**SUNDRY NOTICES AND REPORTS ON WELLS**  
*Do not use this form for proposals to drill or to re-enter an abandoned well. Use form 3160-3 (APD) for such proposals.*

8. Well Name and No.  
 Arroyo Vista 14 Federal No. 1

Change of Plans  
**Arroyo Vista 14 Federal No. 1**  
Cimarex Energy Co. of Colorado  
Unit I, Section 14  
T22S R22E; Eddy County, NM

Revised Pit System and Well Site Layout

Exhibit A  
 REVISED Rig Layout Diagram  
 Surface & Intermediate Casing  
**Arroyo Vista 14 Federal No. 1**  
 Cimarex Energy Co. of Colorado  
 14-22S-22E  
 1980' FSL & 660' FEL  
 Eddy County, NM

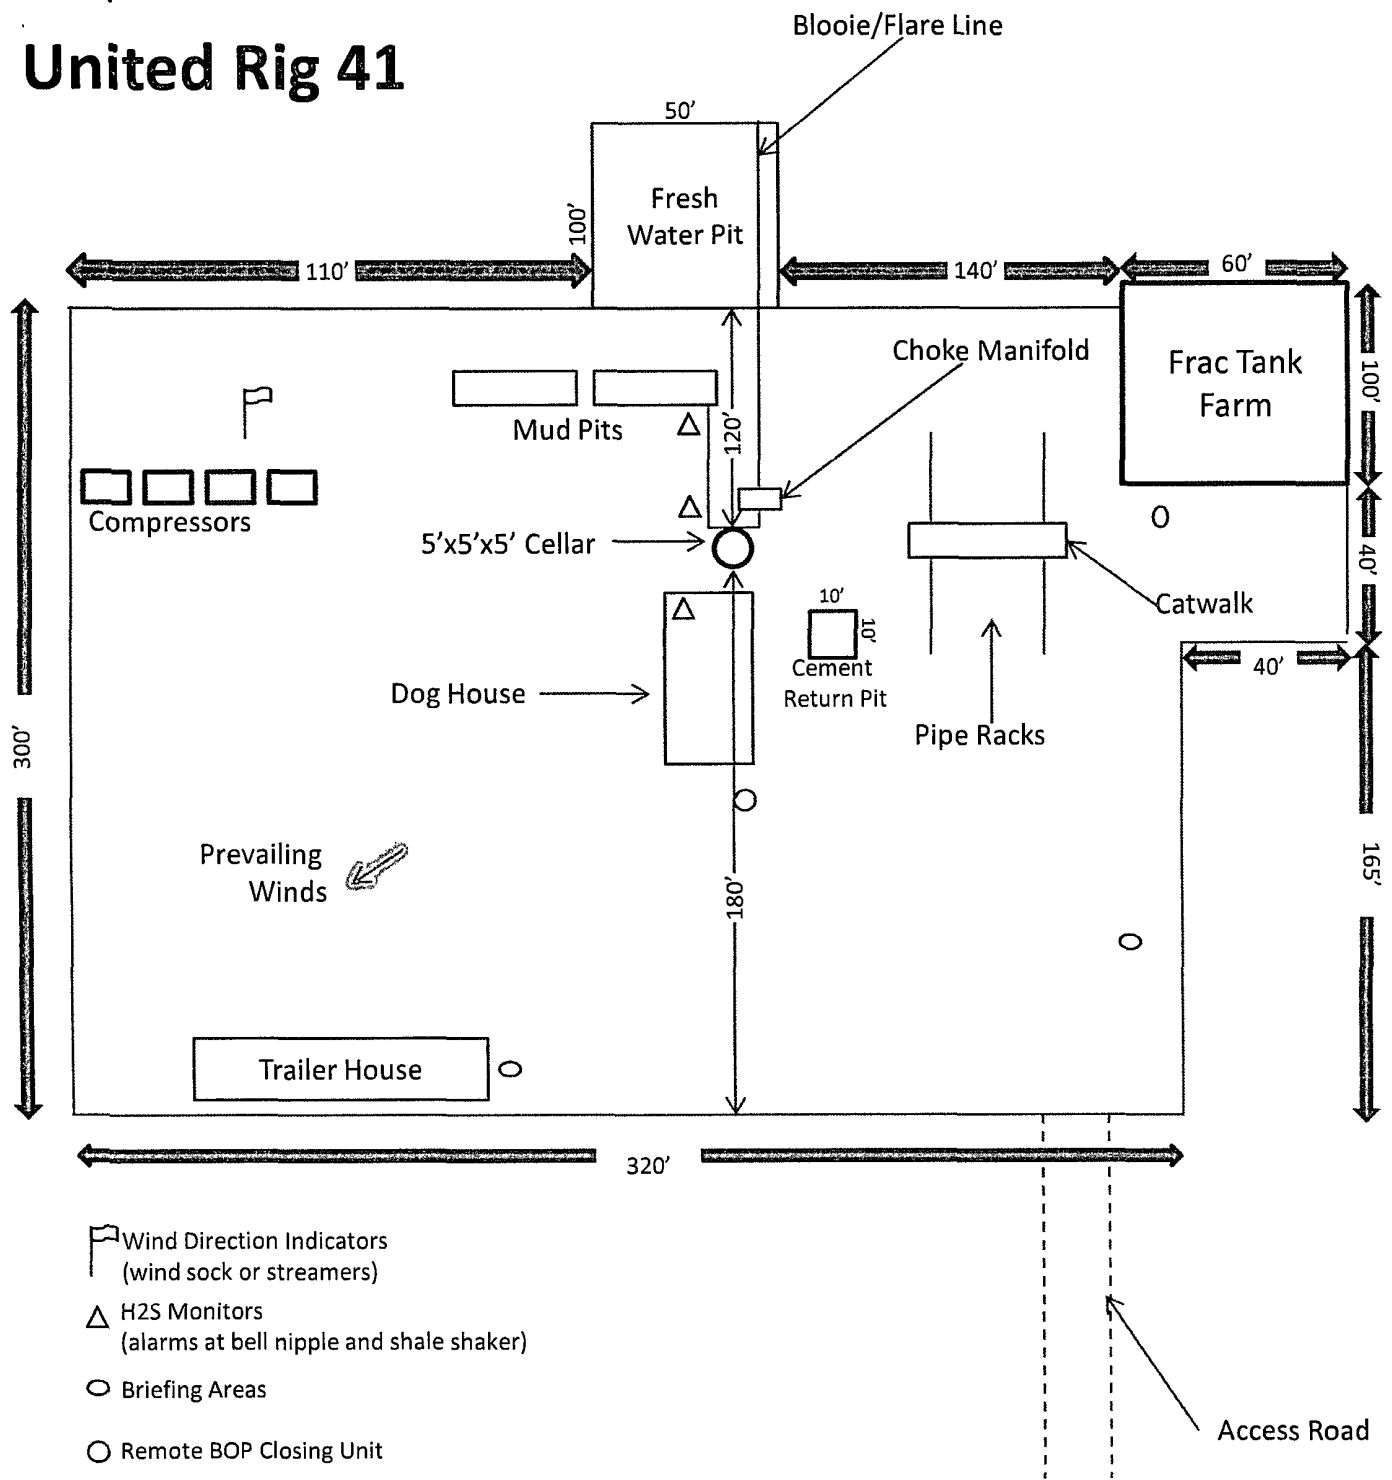
- A. Drill cuttings will be disposed of in the 100' X 50' fresh water pit (Exhibit A).
- B. Drilling fluids will be contained in the fresh water pit. Fresh water produced during drilling will be circulated into and contained in the pit or steel tanks if volumes become excessive.
- C. Remaining drilling fluids will be allowed to evaporate in the fresh water pit until the pit is dry enough for breaking out. In the event that drilling fluids do not evaporate in a reasonable time they will be hauled off by transports and be disposed of at a state approved disposal facility. Later pits will be broken out to speed drying. Water produced during testing will be put in reserve pits. Any oil or condensate produced will be stored in test tanks until sold and hauled from the site.

- A. These exhibits indicate proposed location of the 100' X 50' fresh water pit.
- B. Mud pits in the active circulating systems will be steel pits and the fresh water pit will be lined with a 12 mil liner.
- C. The fresh water pit will be fenced on three sides with four strands of barbed wire during drilling phases. The fourth side will be fenced after all drilling operations have ceased.

**Exhibit B**  
 REVISED Rig Layout Diagram  
 Production Casing  
**Arroyo Vista 14 Federal No. 1**  
 Cimarex Energy Co. of Colorado  
 14-22S-22E  
 1980' FSL & 660' FEL  
 Eddy County, NM

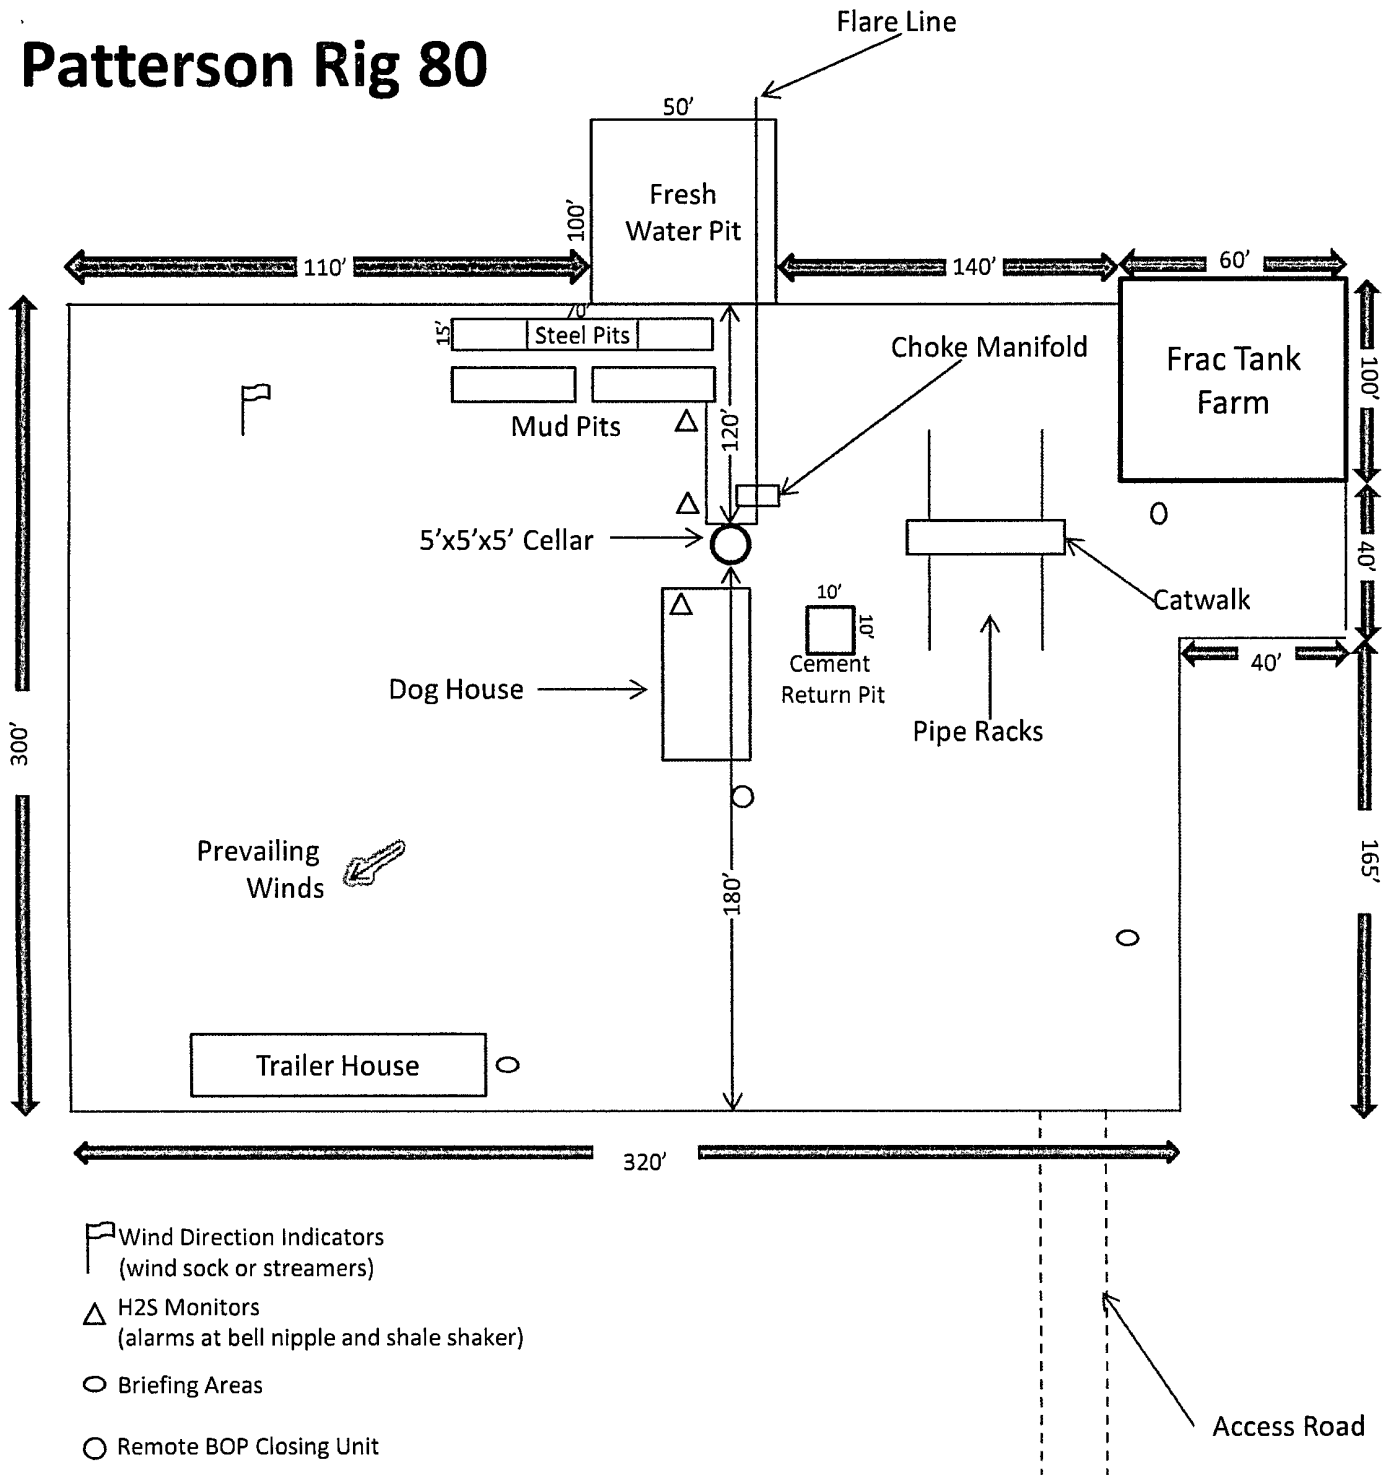
- A. These exhibits indicate proposed location of the 70' X 15' steel storage and haul-off bins (Exhibit B).
- B. Mud pits in the closed circulating systems will be steel pits. Cuttings will be stored in steel pits until they are hauled to a state-approved disposal facility or buried.

Exhibit E-1  
REVISED BOP  
**Arroyo Vista 14 Federal No. 1**  
Cimarex Energy Co. of Colorado  
14-22S-22E  
1980' FSL & 660' FEL  
Eddy County, NM

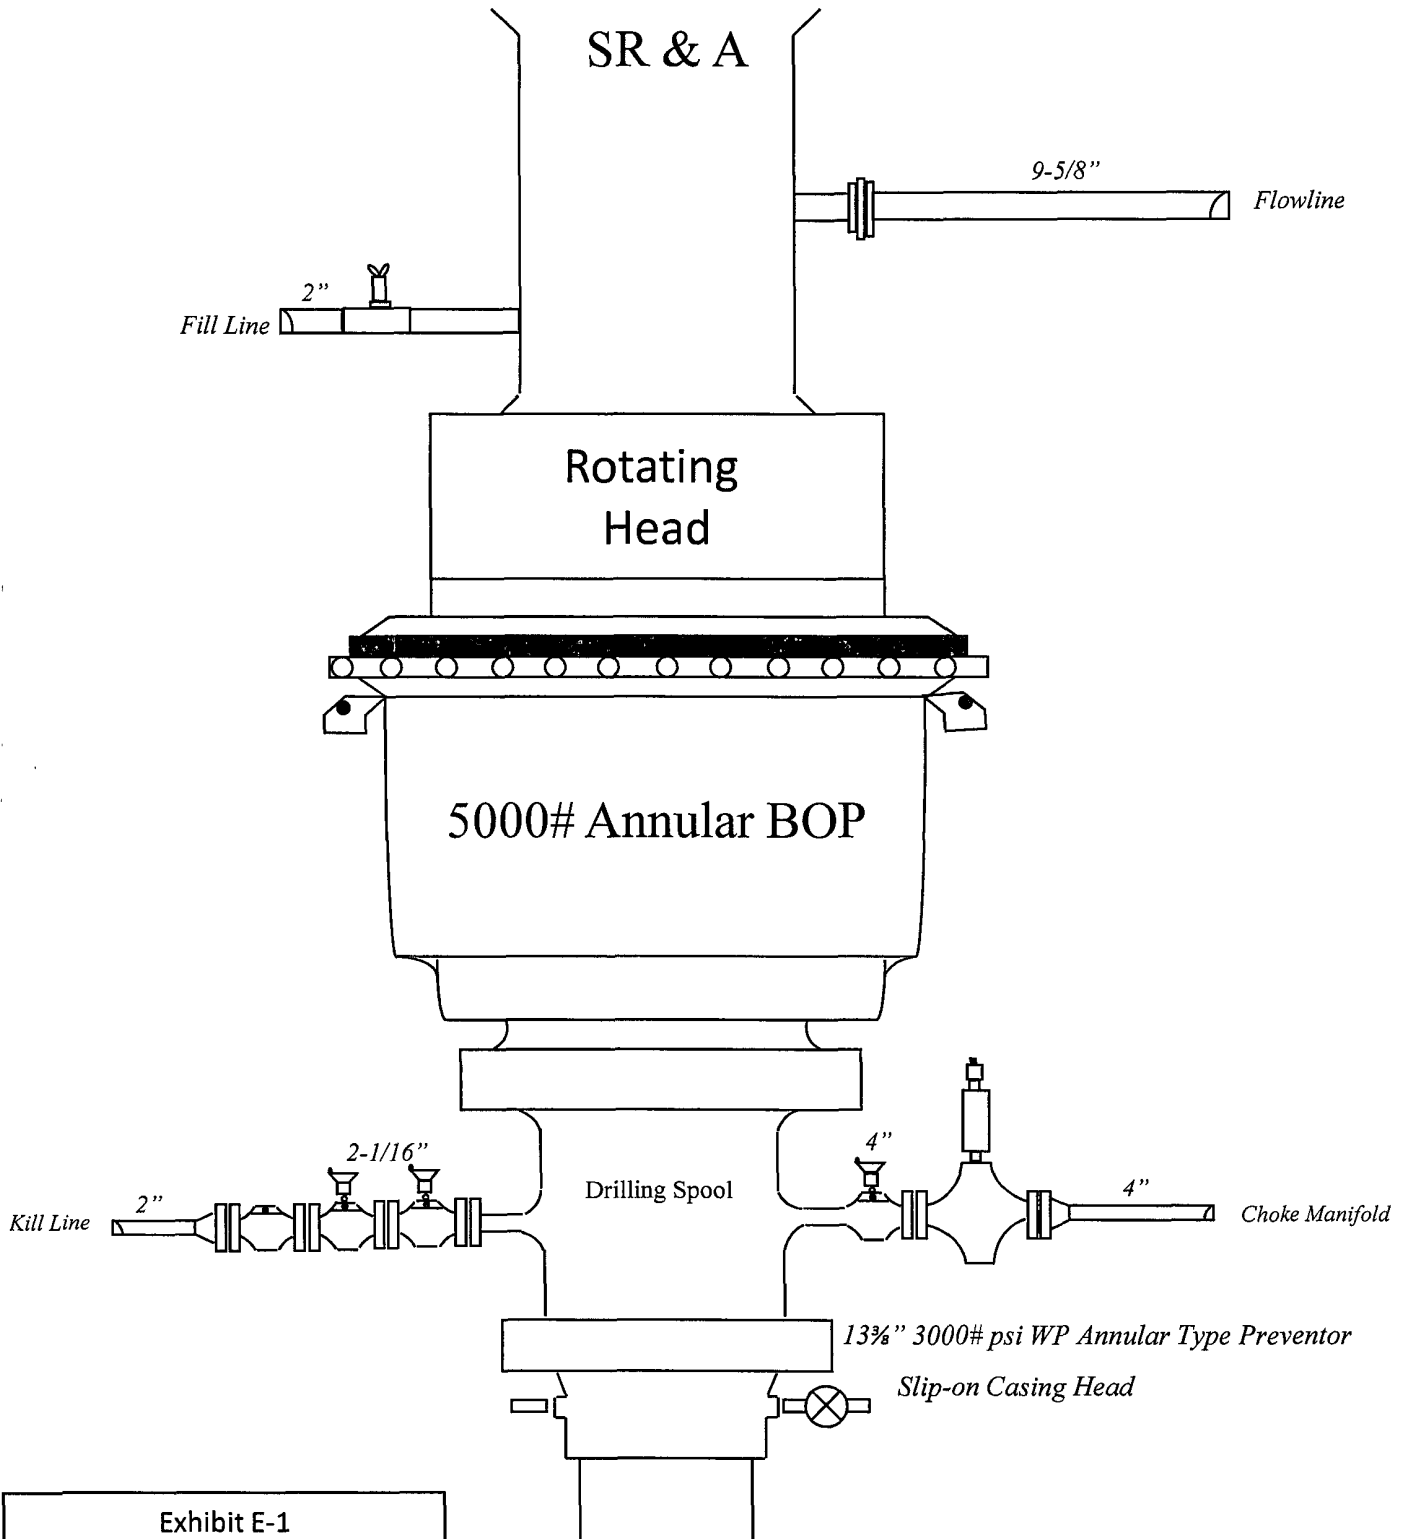
Exhibit "E-1" - Surface & Intermediate Casing - An 13 $\frac{3}{8}$ " 3000 PSI minimum working pressure B.O.P. consisting of a 5000# annular type preventer with rotating head. A choke manifold and 120 gallon accumulator with floor and remote operating stations and auxiliary power system. A kelly cock will be installed and maintained in operable condition and a drill string safety valve in the open position will be available on the rig floor. Annular preventor to be function-tested once per day. Annular preventor will be tested to 250 psi low and 2500 psi high, by an independent service company.

- f. A variance to test only the surface casing to the reduced pressure of 1000 psi with the rig pumps is approved. **The BOP/BOPE will be tested to 5000 psi by an independent service company.**

Exhibit E-2  
REVISED BOP  
Arroyo Vista 14 Federal No. 1  
Cimarex Energy Co. of Colorado  
14-22S-22E  
1980' FSL & 660' FEL  
Eddy County, NM

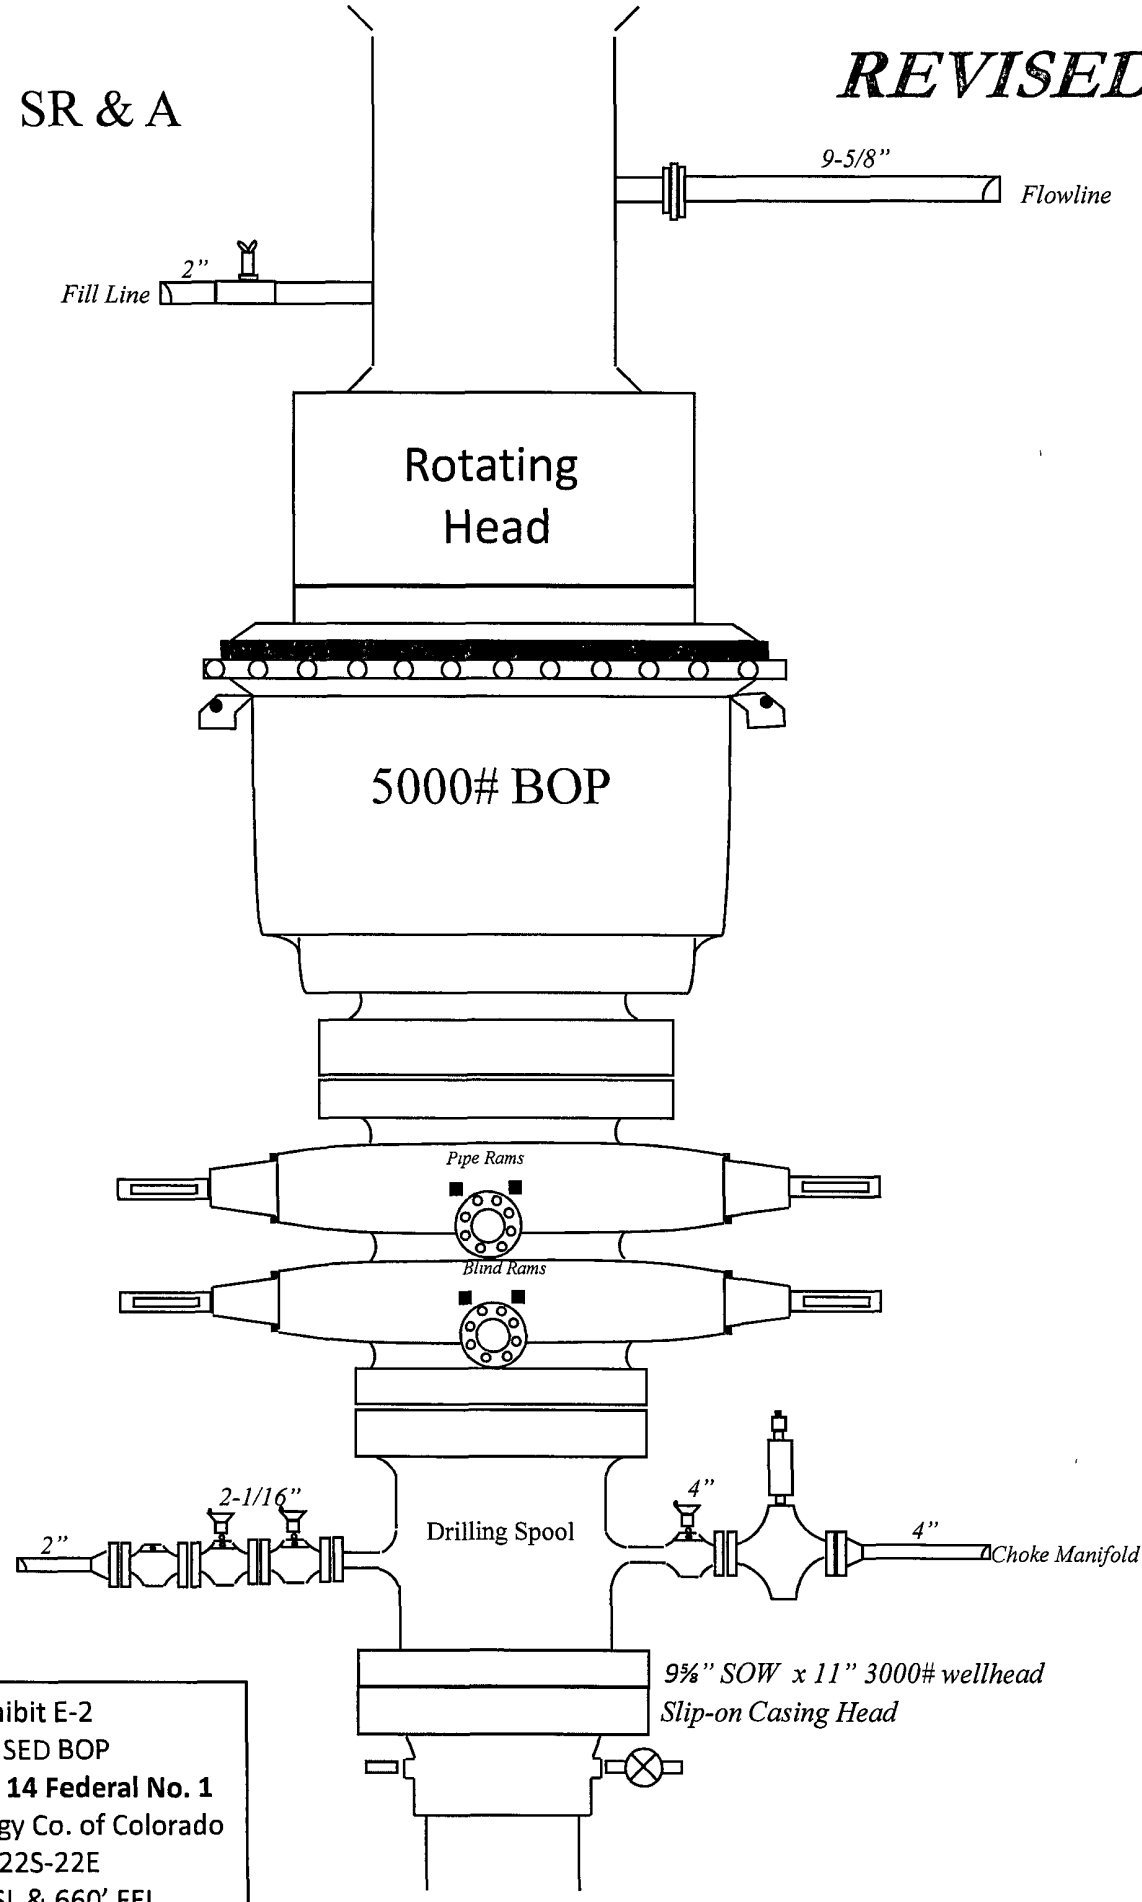
Exhibit "E-2" - Production Casing - A 9 $\frac{5}{8}$ " 5000 PSI working pressure B.O.P. consisting of one set of blind rams and one set of pipe rams and a 5000# hydril. A choke manifold and 120 gallon accumulator with floor and remote operating stations and auxiliary power system. Rotating head below 2210'. A kelly cock will be installed and maintained in operable condition and a drill string safety valve in the open position will be available on the rig floor. Ram-type BOP to be tested to 250 psi low and 2500 psi high by an independent service company.
